SEAS DEADLINE 6 RESPONSE to APPLICANTS's SUBMISSIONS
SINCE DEADLINE 5, ISH3, Action Points and ExQ3
LANDSCAPE & VISUAL and CULTURAL HERITAGE

PINS Ref: EN020026
DEADLINE 6: APRIL 13, 2026

EN020026 SEA LINK DCO – DL6: RESPONSE BY NICHOLAS BRIDGES

ZTV ANALYSIS – IP ref FA62B0DA

Figure 6. Sea Link 2023-10 PEIR Volume 3 Part 2 Chapter 2 Figures A, page 8:
 REPRESENTATIVE VIEWPOINT LOCATIONS AND SCREENED ZONE OF THEORETICAL VISIBILITY - PROPOSED SAXMUNDHAM CONVERTER STATION AND SPR FRISTON SUBSTATION (OPTION 1)

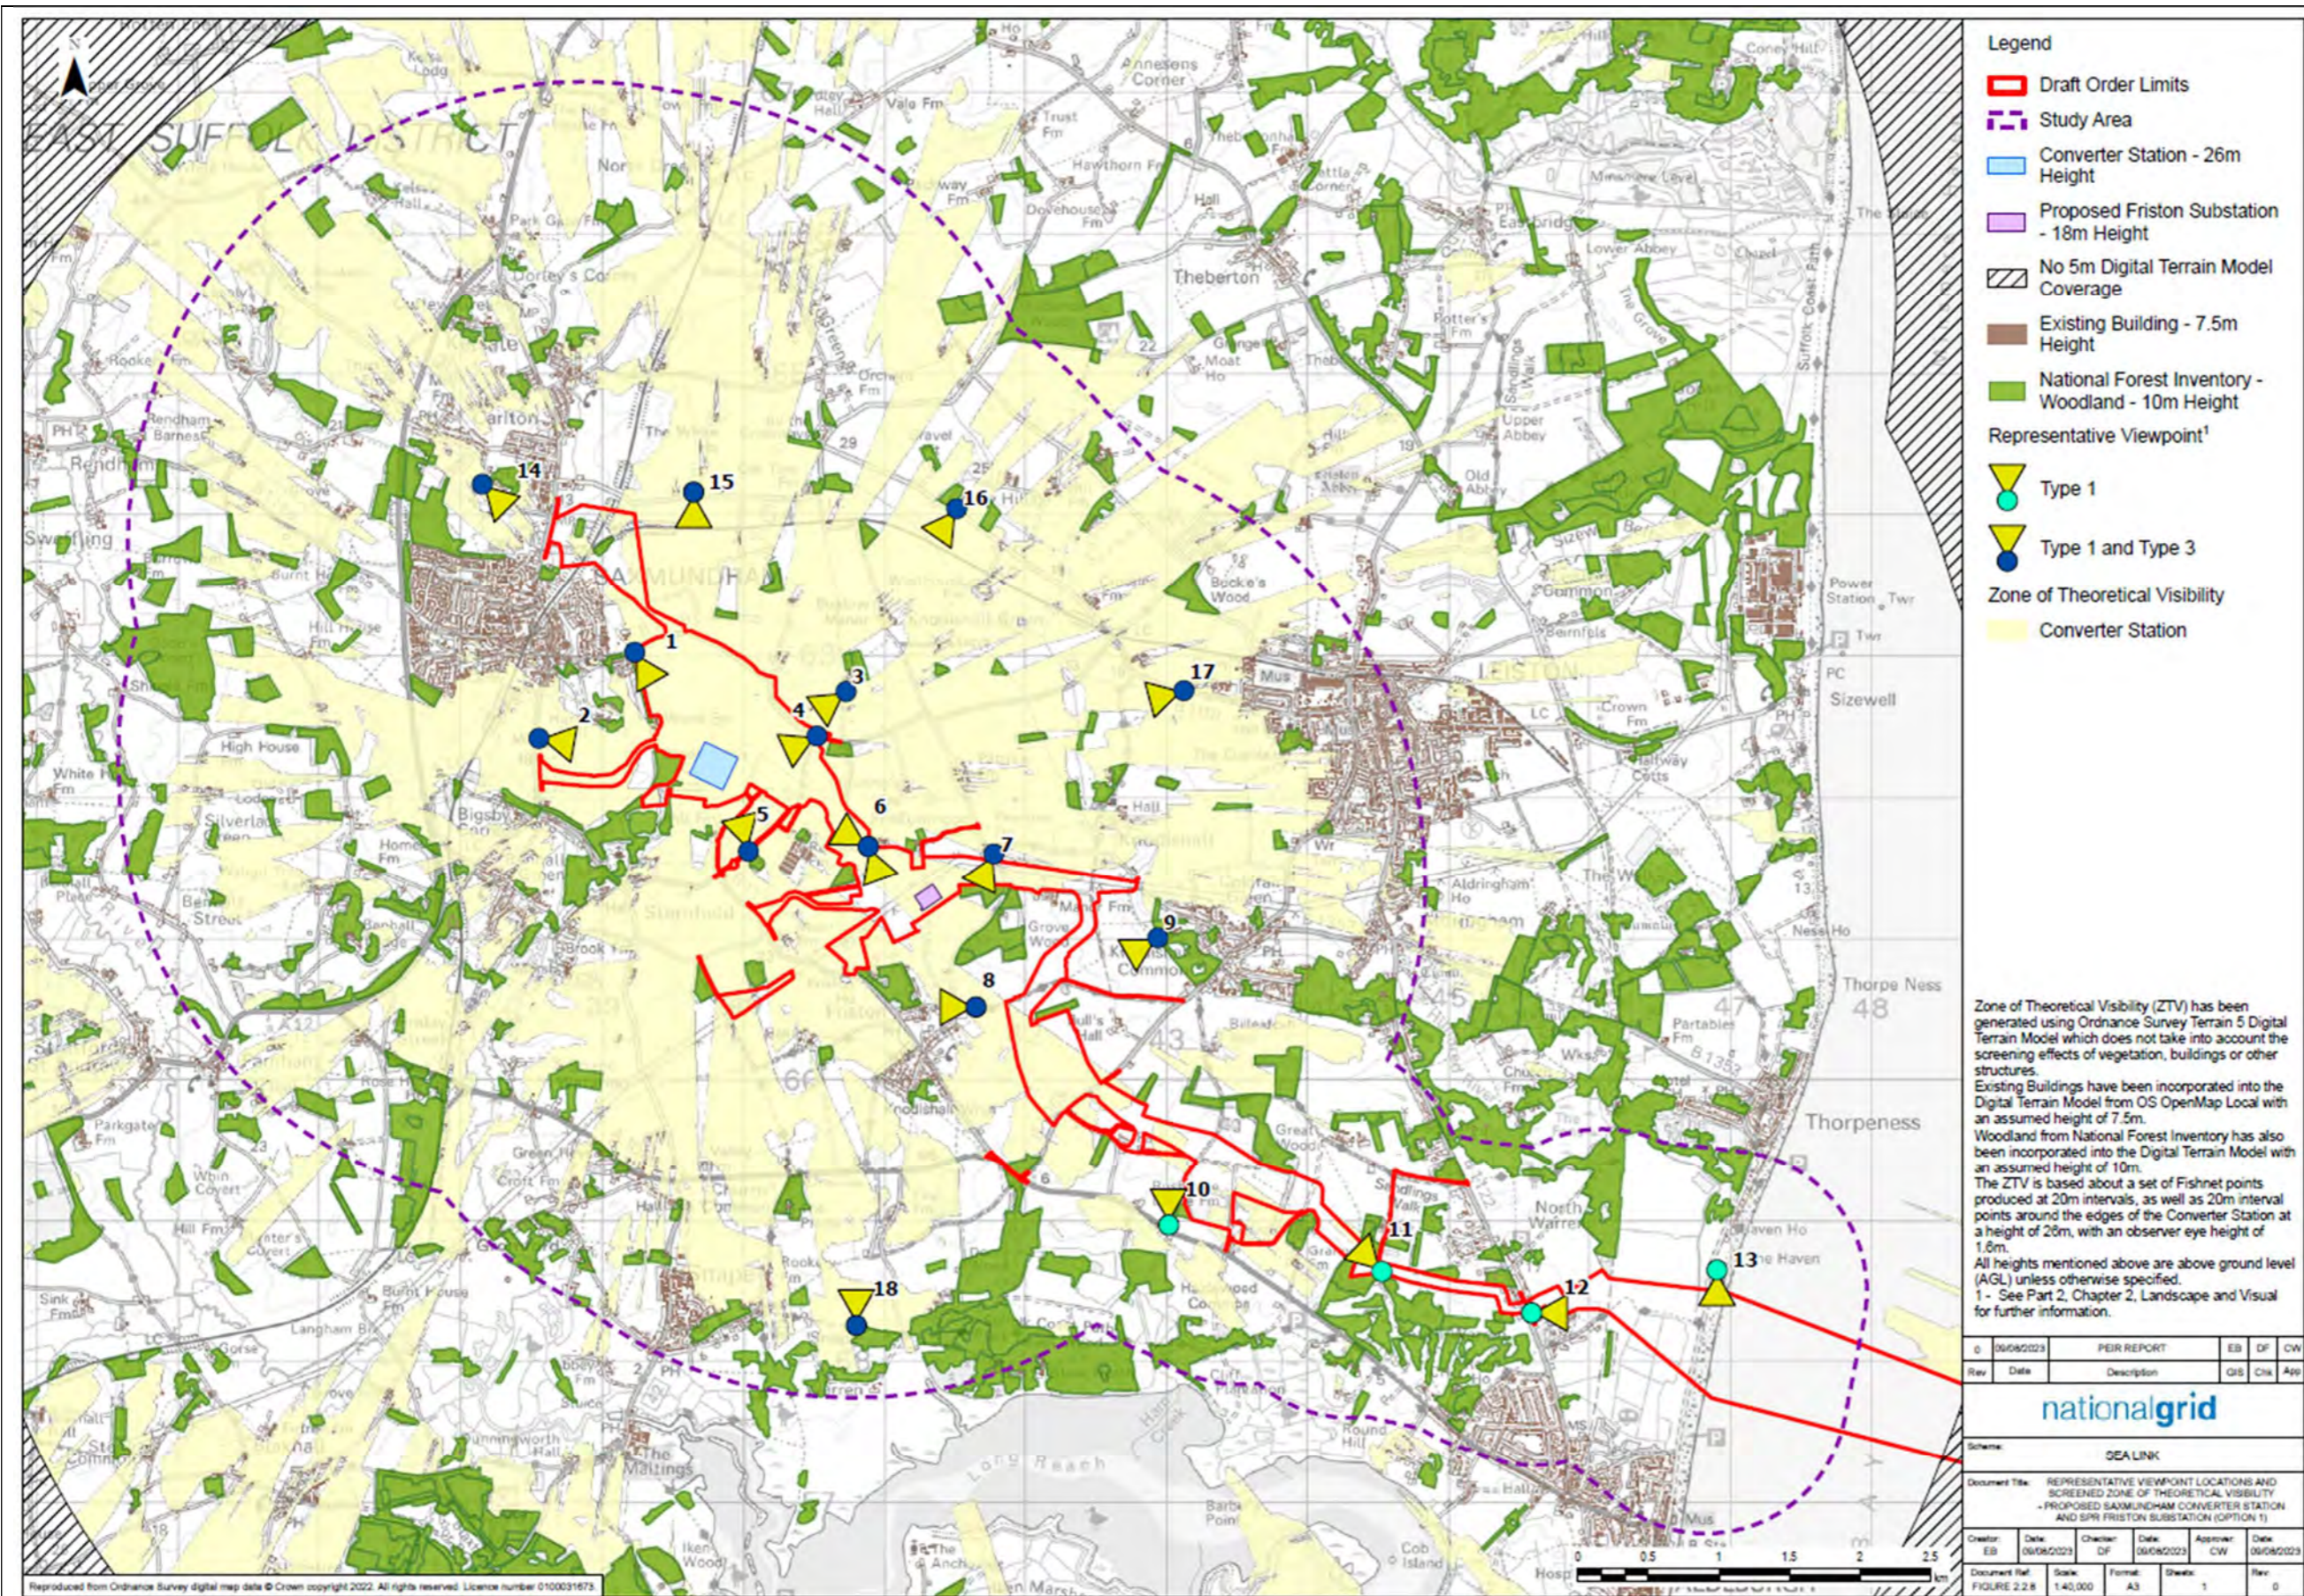
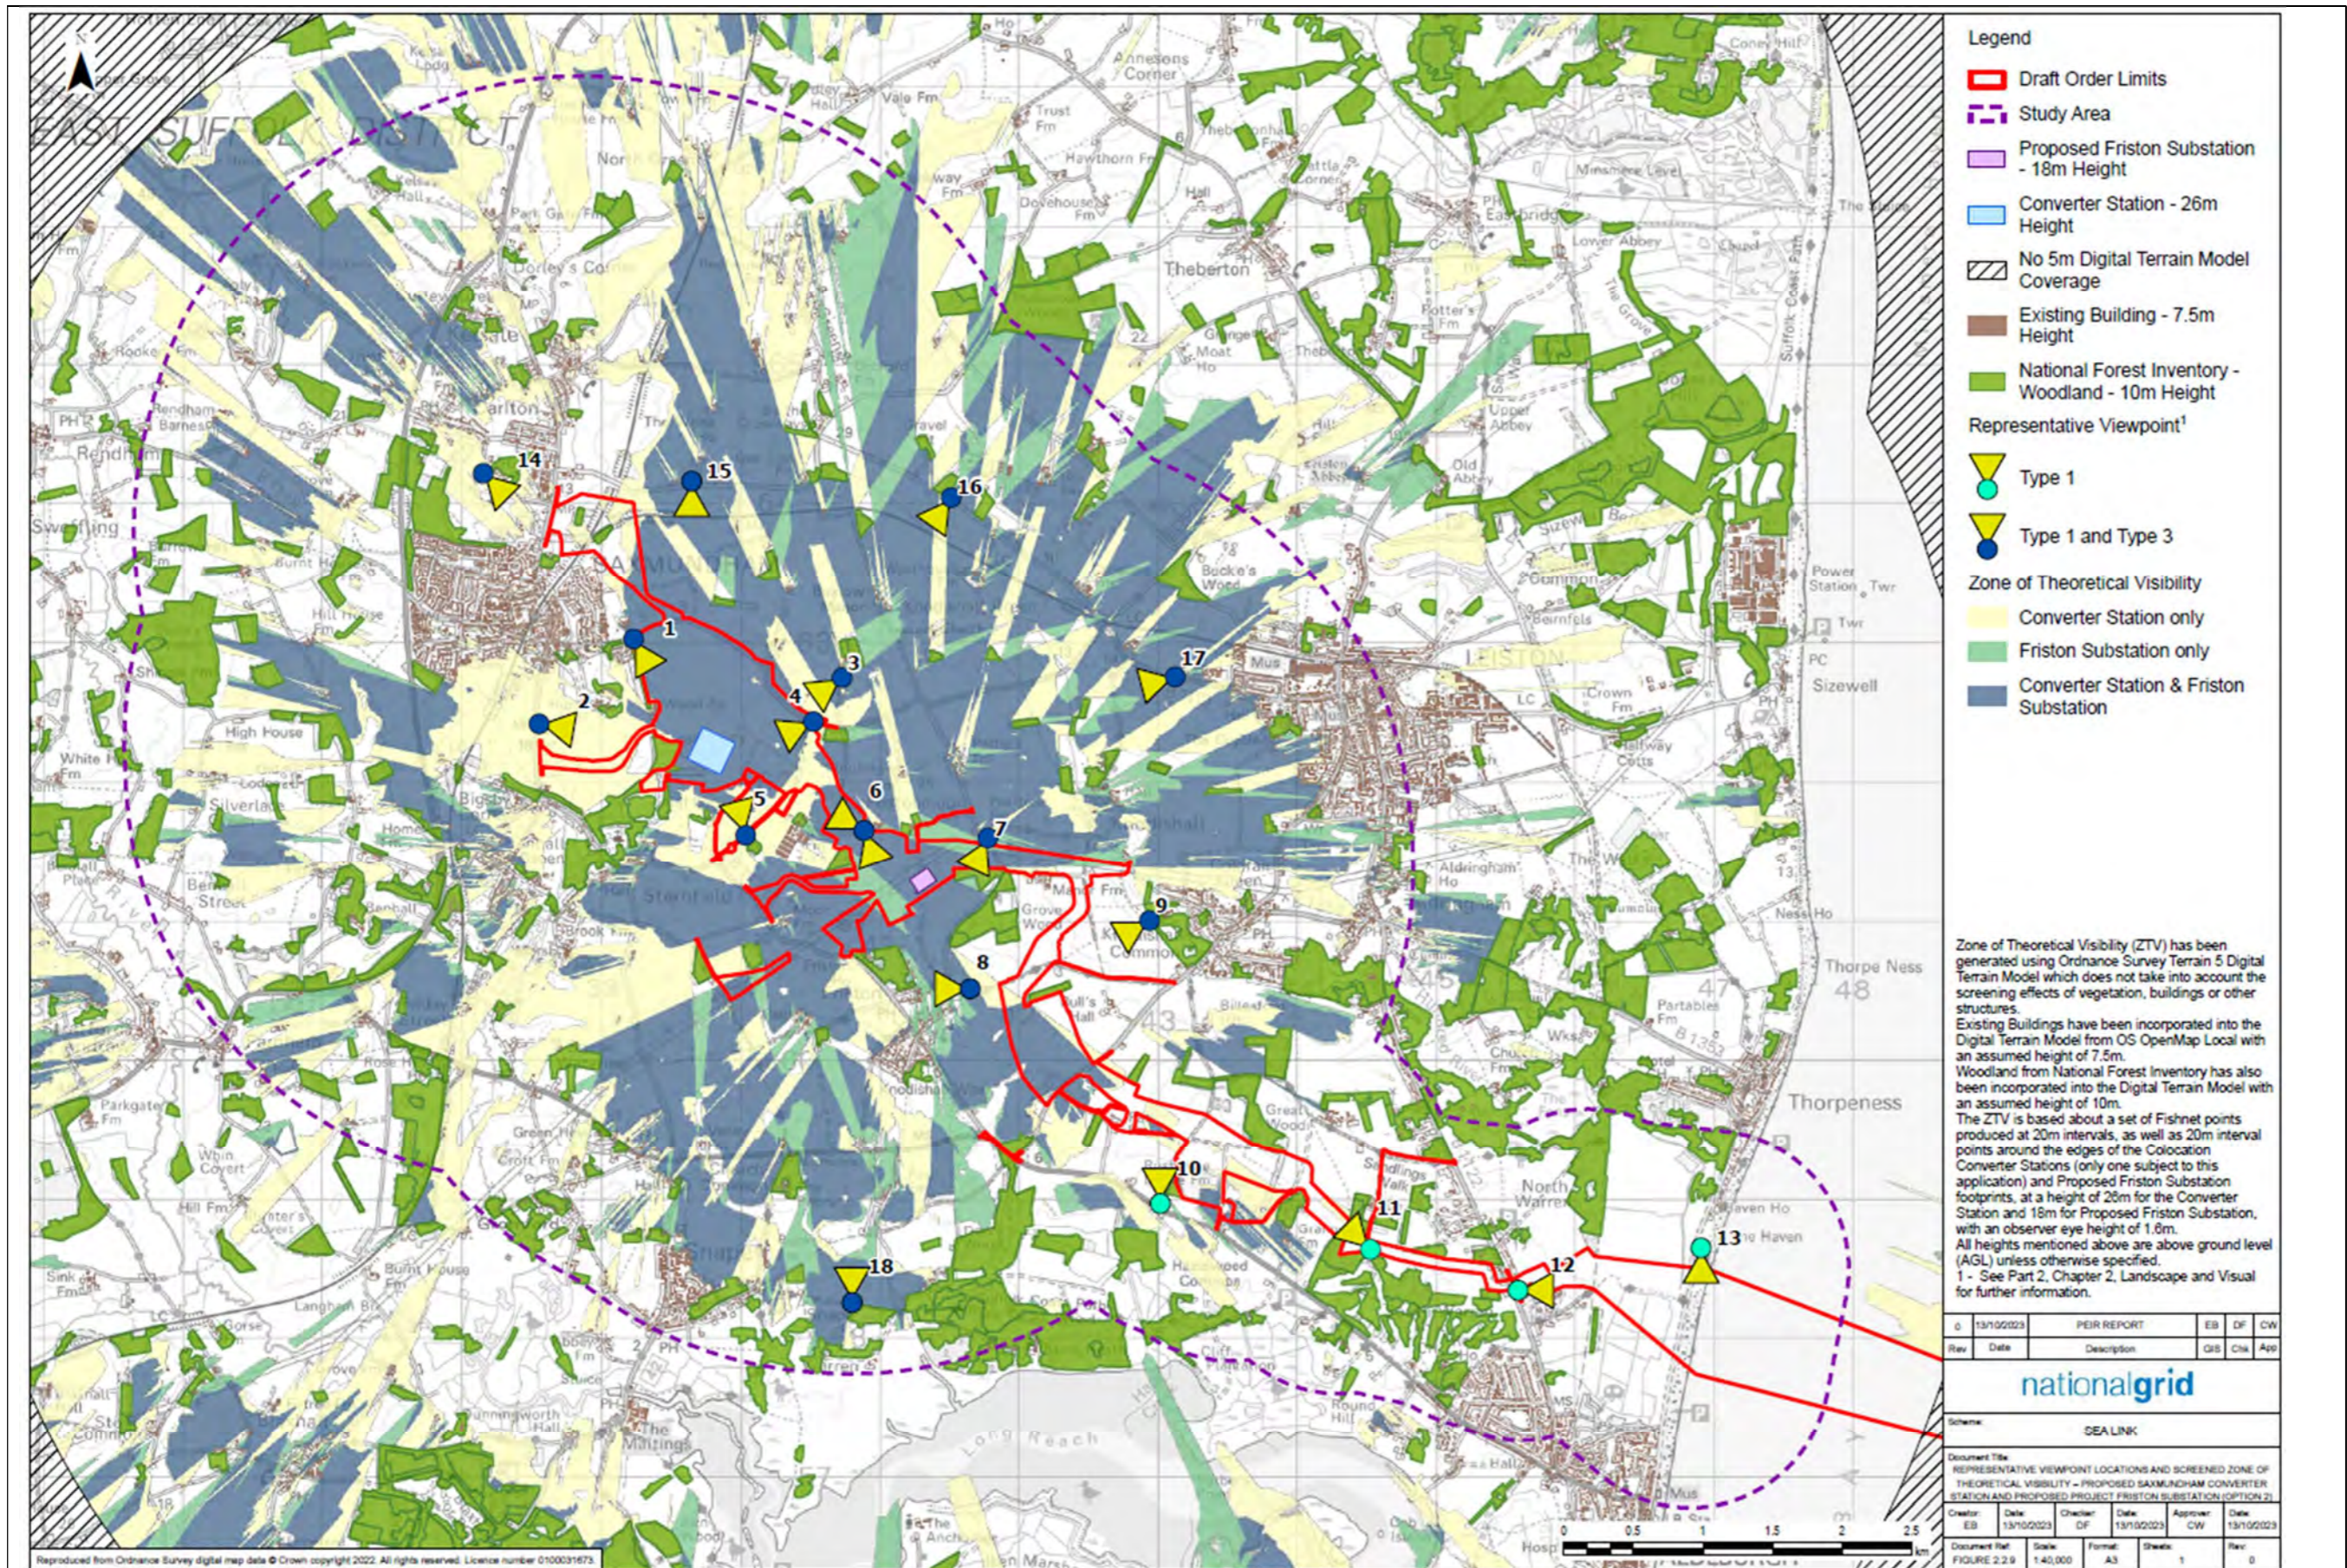
2.9. The ZTVs of the two Friston projects and Sea Link's PEIR have a similar pattern of visibility around their projects (see **Figures 1 to 11** below). Sea Link includes the National Grid substation at Friston which each of EA1N and EA2 also included. All Projects were modelled using OS contours, woodland and buildings at a generic height. Observer heights were a little higher for EA1N and EA2. The two Friston substations used the same parameter model as Sea Link.

2.11. The **first question** is: why are the PEIR and DCO plans so completely different? Were the heights in the model changed? Were the shadowing criteria altered? Which is correct? If the DCO is correct, were the EA1N and EA2 ZTVs incorrect? These are simple technical points which can be explained easily.

2.19. The Sea Link ES LVIA decided not to extend the coverage of its ZTVs when its PEIR had already revealed visibility of the
